Amendments to the Code of Practice for Foundations 2017
(July 2022)

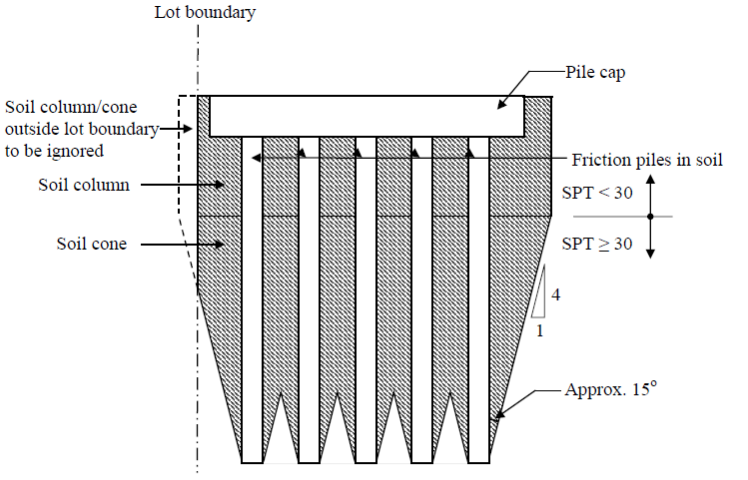
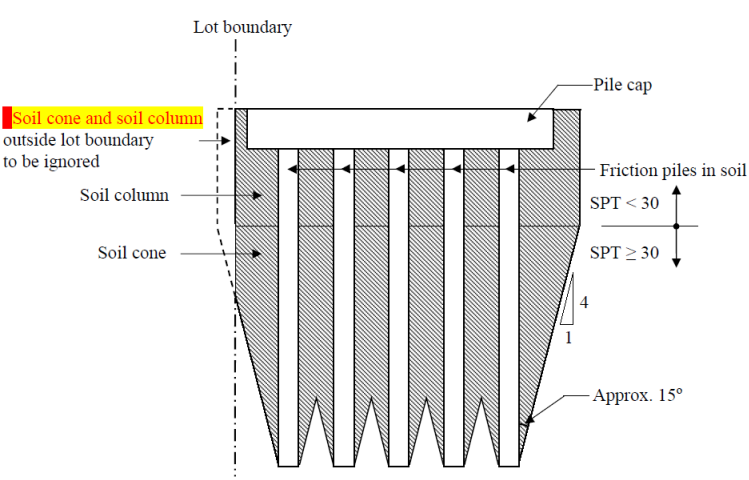
⁶ Clarification on the assessment concerning the rock cone and soil column.
